APPLICATION FOR PERMISSION

For Official Use Only 請勿填寫此欄	Application No. 申請編號	A/YC-MP/379
	Date Received 以到日期	S OCT 2021

回應有關部門的擬問

A/YL-MP/379

雨水排放建議圖

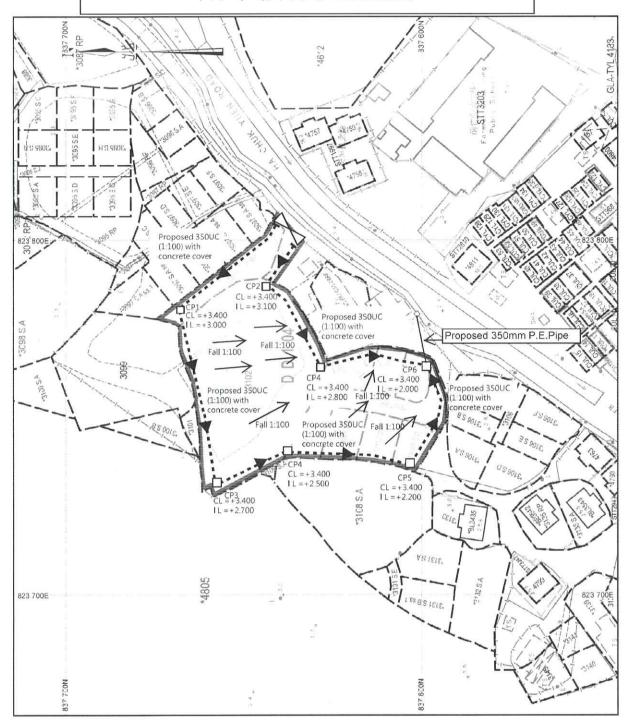
- I have the following comments on the submitted drainage proposal: Please provide a R-to-C table to address our comment below item to item.
- (i) Please provide a R-to-C table to address our comment below item to item.
 (ii) The proposed UC appears to be undersized according to Technical Note to prepare a Drainage Submission. Please review.
- SDM Corrigendum No. 1/2022 and 1/2024 should be considered.

- Please be reminded that GEO Technical Guidance Note No. 43 should be adopted for u-channel checking as Figure 8.7 of the Geotechnical Manual for Slopes (GCO, 1984) was superseded. Please advise if any site formation/land filling works to be carried out under this application.
 - (v) Please advise if any site formation/ land filling works to be carried out under this applica Please note that the overland flow from the adjacent lands should not be affected.
- (vi) Please provide catchment area plan including external catchment areas, if any, for reference.

(vii) Please submit calculation demonstrating the downstream drainage system receiving the
 - discharge from the development has adequate spare capacity to accommodate the runoff.

(viii) UC should be provided at the entrance gate of application site.

The invert levels of the start point of proposed u-channels should he shown on the drain
- The invert levels of the start point of proposed u-channels should be shown on the drainage plan.

- Please indicate clearly the full alignment of the discharge path from the application site all the way down to the ultimate discharge point (e.g. a well-established stream course/public drainage system).

- (xi) According to our record, there are DSD's drains in the vicinity and please also indicate the alignment, flow direction and size of DSD's drains in the drainage plan.

- (xii) The applicant should check and ensure the hydraulic capacity of the existing drainage facilities would not be adversely affected by the captioned development. Please provide site photos to show existing condition and existence of the existing drainage facilities which receive the discharge from the application site.

- (xiii) Hydraulic checking (including velocity and capacity) for the proposed 350mm dia. PB pipe is 1-required.
- (xiv) Please clarify whether any walls or hoarding would be creeted along the site boundary. Where walls or hoarding are erected/ laid along the site boundary, adequate opening should be

(xv) Cross sections showing the existing and proposed ground levels of the captioned site with
- respect to the adjacent areas should be given.

(xvi) Standard details should be provided to indicate the sectional details of the proposed u-channel
 - and the catchpit.
 (xvii) Sand trap or provision alike should be provided before the collected runoff is discharged to the public drainage facilities.

- 1有關問題將在以下作出回應
- 2 有關雨水渠我等已從新設計及提交新一份雨水批放建議圖給貴署審議。
- ,有關提議我等會從新依照貴署的建議作出更改
- 4我等會從新提交有關新一份文件給責署審議
- 5 在是次申請我等不會進行任何平整地盤的工作,
- 6 在新一份雨水排放建議圖內已列明。
- 7 在新一份雨水排放建議圖内已列明。
 - 8 在新一份雨水排放建議圖內已列明。 9 在新一份雨水排放建議圖內已列明。
- 3 年利一 网络水桃灰莲碱画内乌鸡奶10 在新一份雨水排放建議圖內已列明
- 11 在新一份雨水排放建議圖內已列明

12 連同此函的附件交附貴署參考

- 13 為方便日後清理工作,將擬議350mmP.E渠管更改為450mmU型排水渠
- 14 我等只在周邊掛上圍網·方便鄰近地方的雨水通過。
- 15 以附件方式一同交與貴署審議。
- 16 以附件方式一同交與貴署審議
- 17 我等所有集水井都設有沙坑。
- 18 我等不用進行平整地盤的工作,只在建設排水渠時才會進行工程,在進行渠道工程時,我等會小心保護鄰近河道及渠道的工作
- 19 如獲排准,我等在建設渠道前會先向元朗地改處取得官地挖掘許可,才會作行施工。 我等同意在渠務署要求下准許其他人士連接我等渠道至政府渠道,渠道日後如有需要 修改升級有關渠道時,我等同意支付有關費用。
- 50 在接駁政府渠道完工時我等會向渠務署提交HBb1及連同審核費用的支票一同交給渠務署申請審核工序。

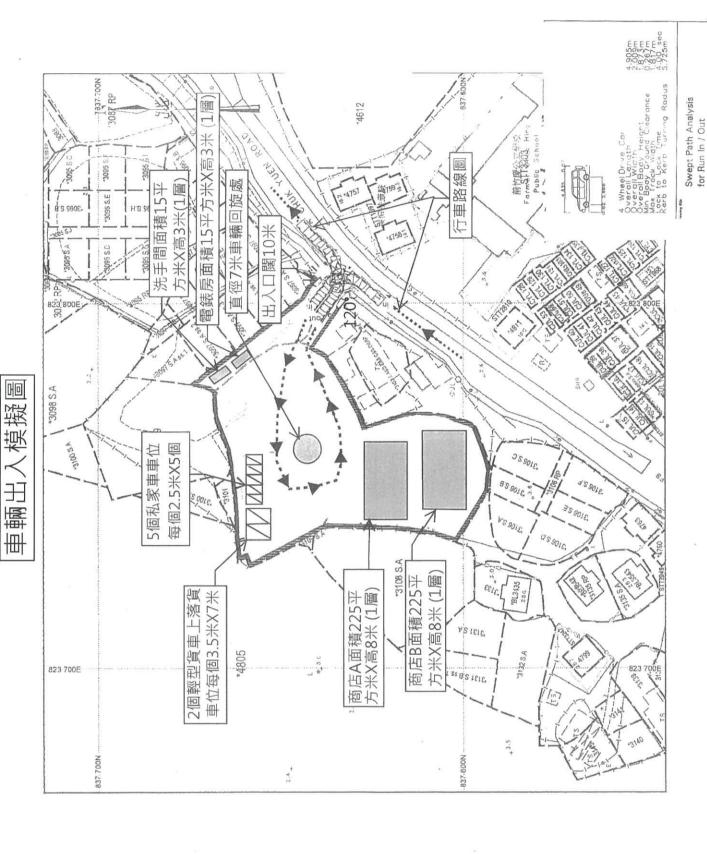
(c) The applicant should provide details of trip generation and attraction rates for the proposed use in the application and advise if there is any adverse impact to nearby traffic.

(d) The applicant should provide the estimated number of visitors during peak hour and total number of employee(s) for the proposed use in the subject site to justify the sufficiency of car parking spaces.

我等會以附件方式回應有關問題。

我等會以附件方式回應有關問題。
